UNITED STATES ENVIRONMENTAL PROTECTION AGENCY

AMENDED FINDING OF NO SIGNIFICANT IMPACT

Proposed Project: New Cut Dune/Marsh Restoration Project (TE-11a/TE-37) in Terrebonne Parish, Louisiana.

Figure 1: New Cut Dune/Marsh Restoration Project TE-37

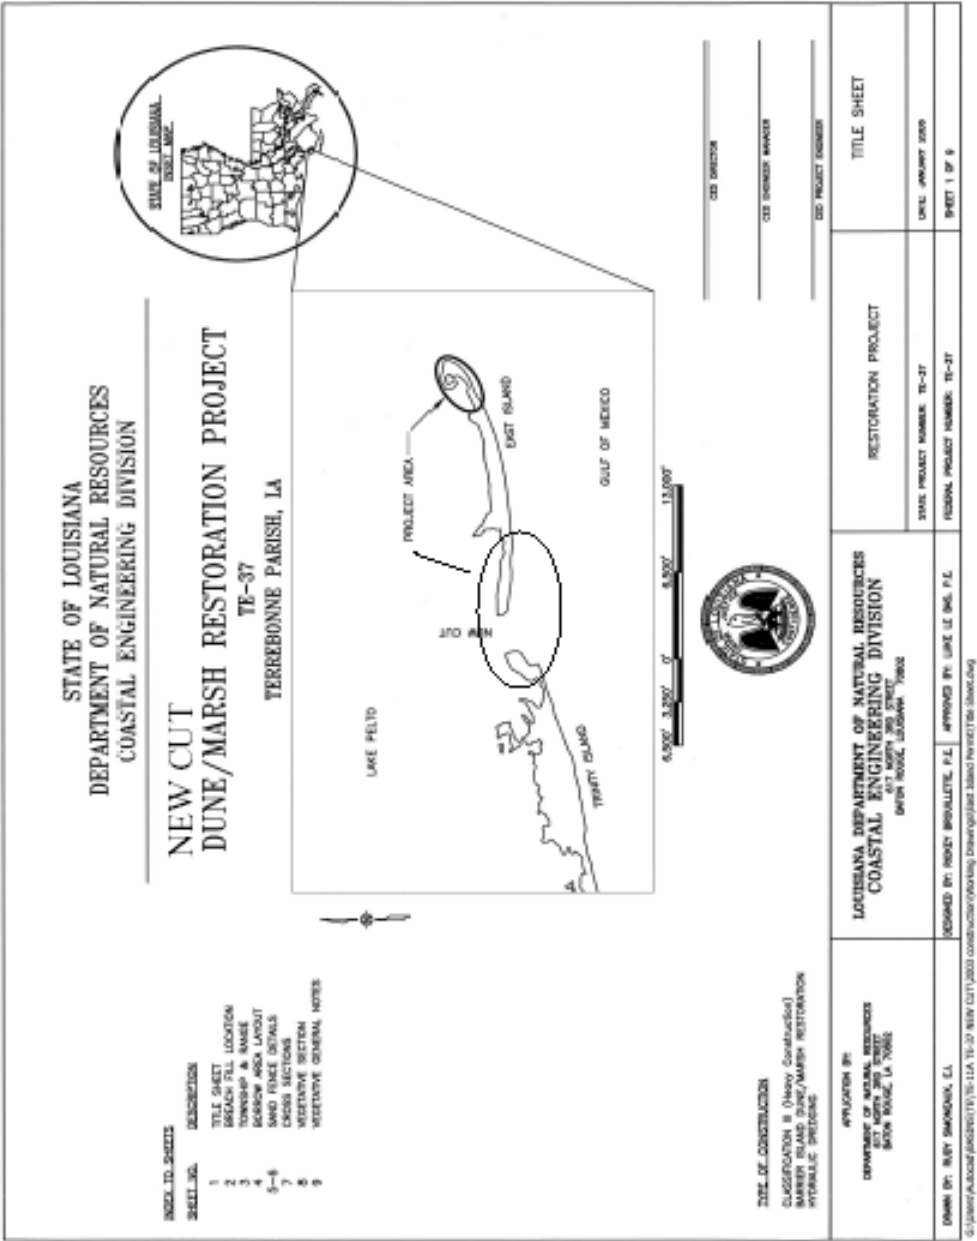
Proposed Project: The proposed project would restore approximately 8,000 linear feet (l-ft) of barrier island between Trinity Island and East Island, using approximately 830,650 cubic yards (cy) of sand, 7,500 l-ft of containment dike, and 17,050 l-ft of sand fencing. The present changes will use 970,000 cy of beach fill and 4,400 l-ft of sand fencing. Portions of the fill area have naturally accreted towards the design elevation of +4.0 NAVD88 (North American Vertical Datum of 1998), reducing the extent of the gulf side berm. The western end of the island near California Canal was included in the design template. Additional details can be found in the design report and the final plans and specifications.

Figure 2: Borrow Area Layout New Cut Dune

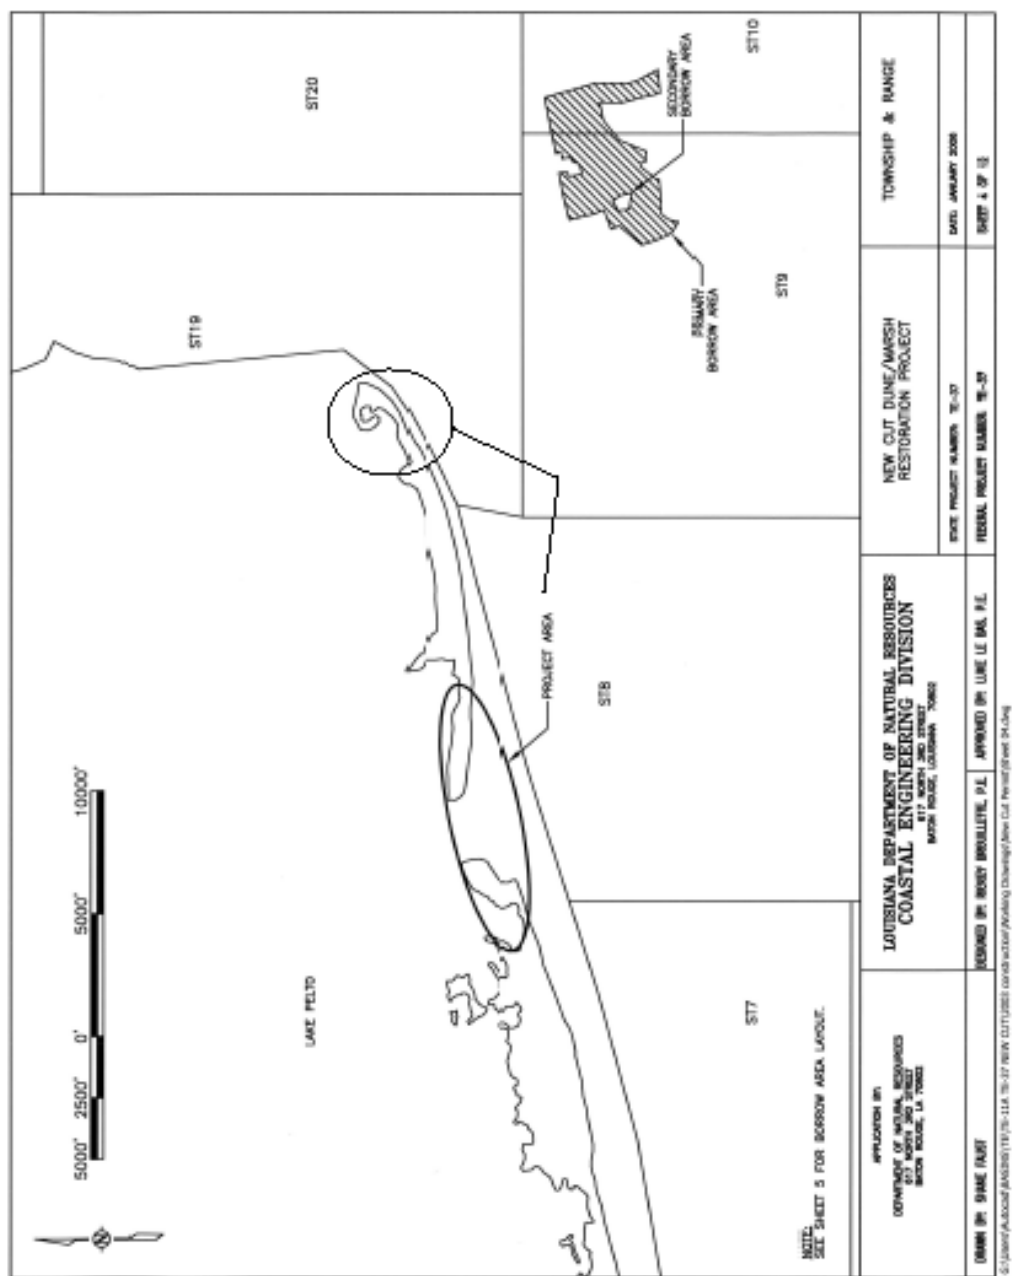
In accordance with the environmental review guidelines of the Council on Environmental Quality at 40 Code of Federal Regulations (CFR) Part 1500, the U. S. Environmental Protection Agency (EPA) has reviewed the requested design change of the proposed project to change the primary borrow site to a new sand source and to repair a small breach near the eastern end of East Island under the authority of the Coastal Wetlands Planning, Protection and Restoration Act (CWPPRA) of November 1990, House Document 646, 101st Congress (Public Law 101-646).
